Monticello Nuclear Generating Plant  
2807 W County Rd 75  
Monticello, MN 55362

L-MT-14-082  
10 CFR 72.7

Exemption Request for Dry Shielded Canisters 11 - 16 Due to Nonconforming Dye Penetrant Examinations, Supplemental Information (TAC No. L24939)

### RESPONSE TO NRC REQUEST FOR SUPPLEMENTAL INFORMATION

**Figure 7. OTCP Postulated Flaw Configuration – Circumferential #3**

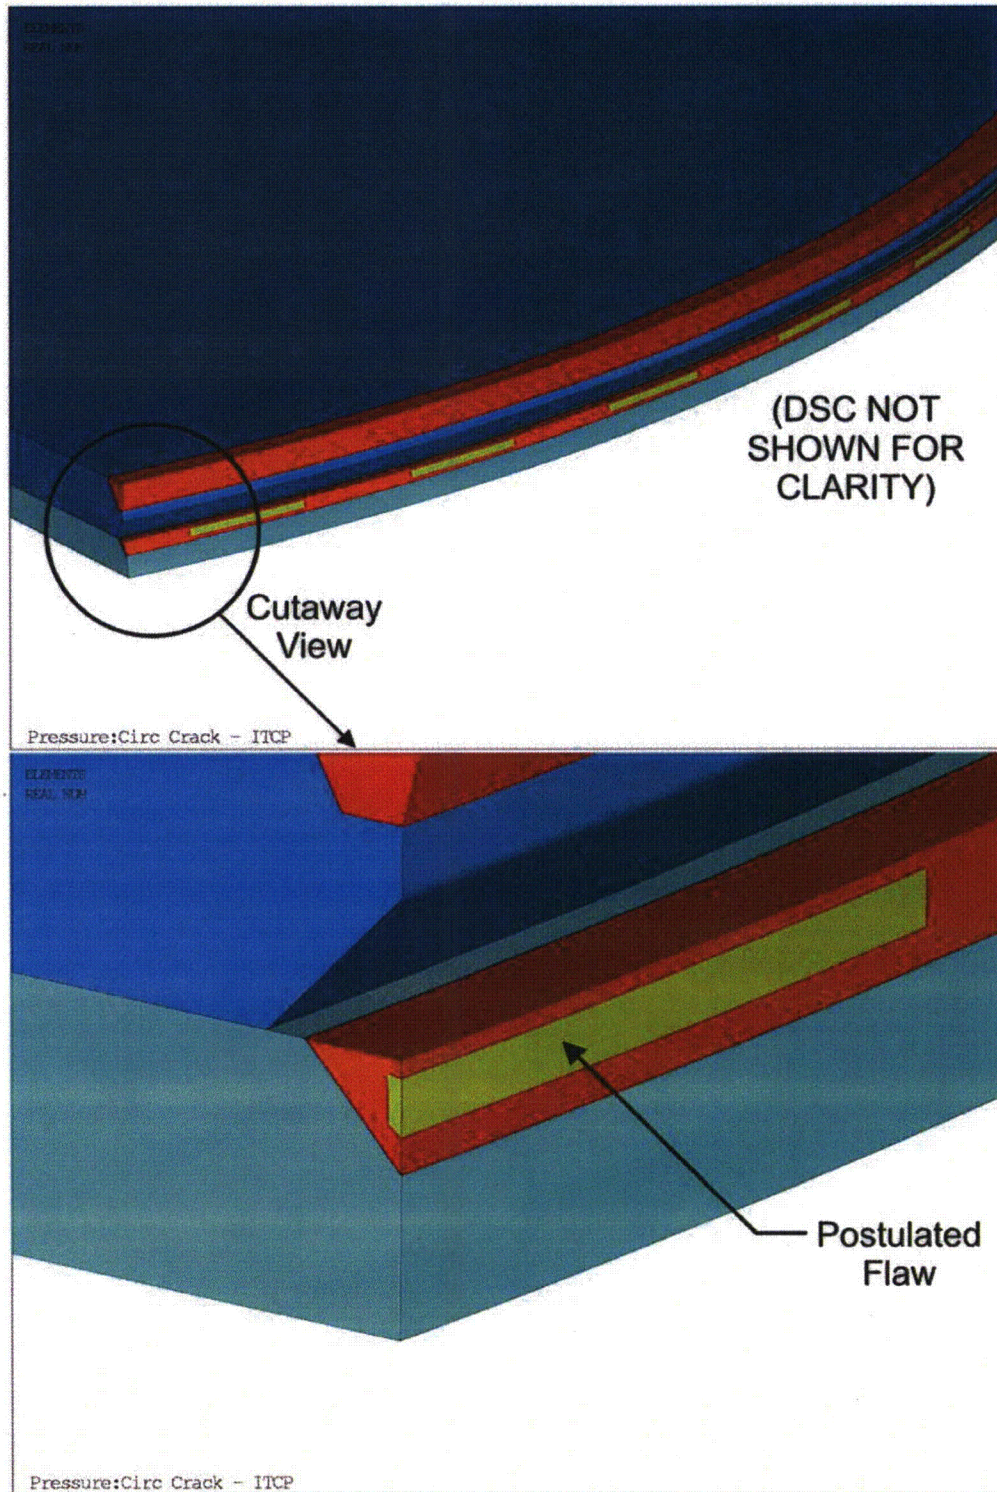
The circumferential flaw, Configuration 3, shown in Figure 7, is a full height (through-wall) flaw, 1" long and occurring every 5". The 1" in 5" spacing is a 20% occurrence of postulated flaws, which although less than 25%, is tempered by the fact that the analyzed flaw is full height, not the expected one bead thickness dimension (~ 1/8") described above. With this consideration, the Configuration 3 circumferential flaw bounds the "conservatively assumed" flaw stated in Reference 1.

**Figure 9. ITCP Postulated Flaw Configuration – Circumferential**

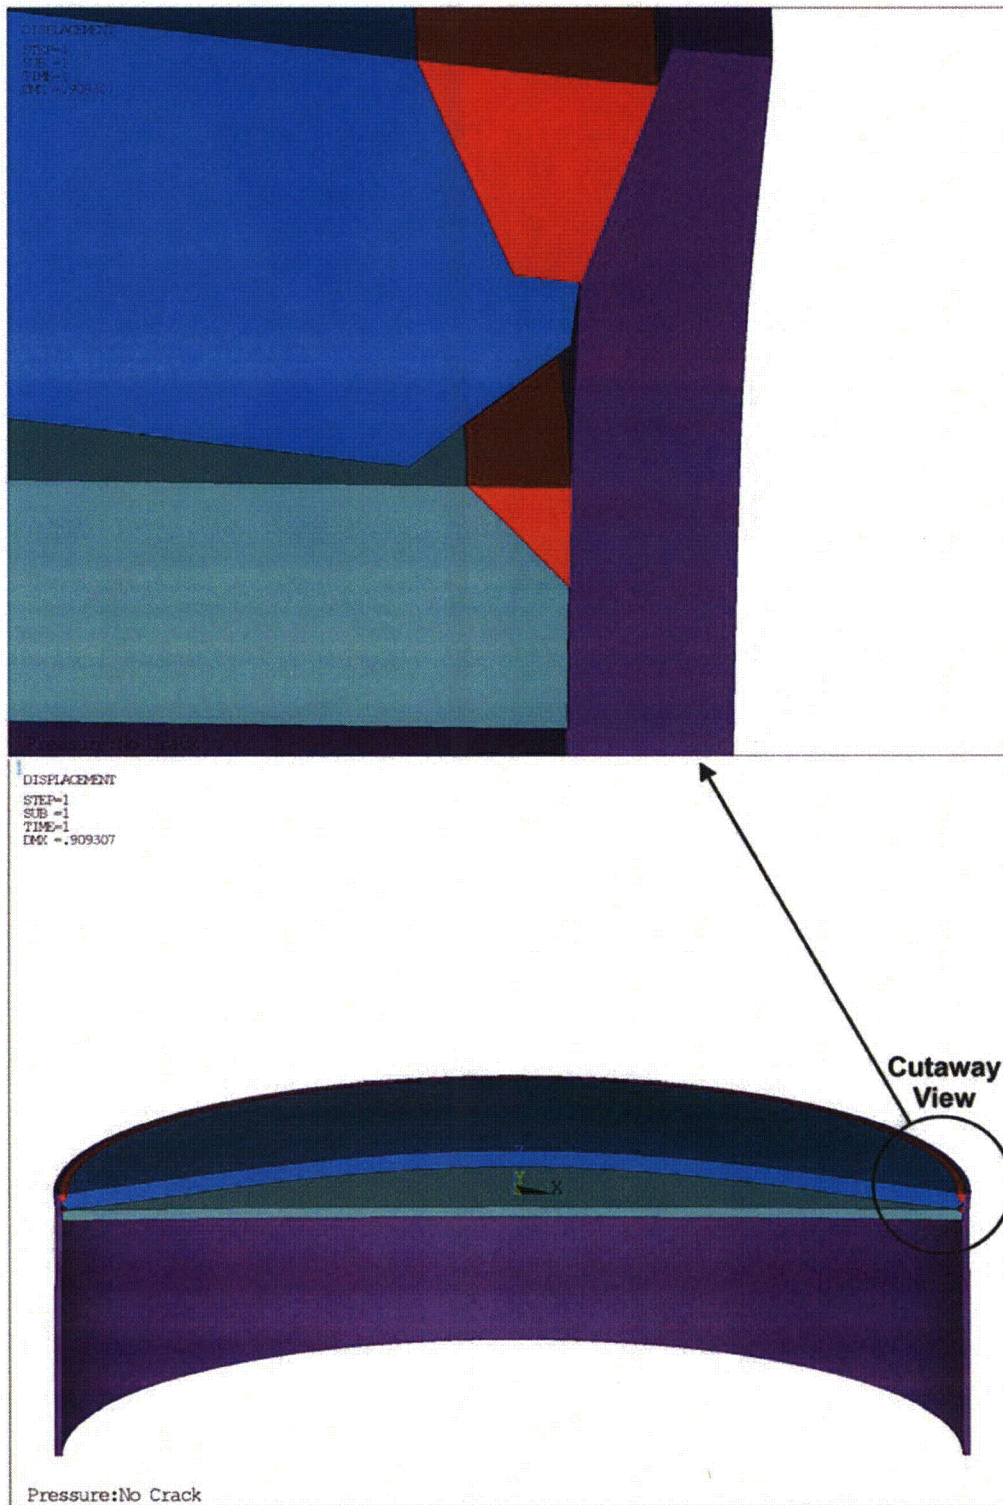
ITCP: The 360 degree embedded flaw postulated and evaluated (Figure 9), is much more adverse than the expected flaw of Reference 1 described above.
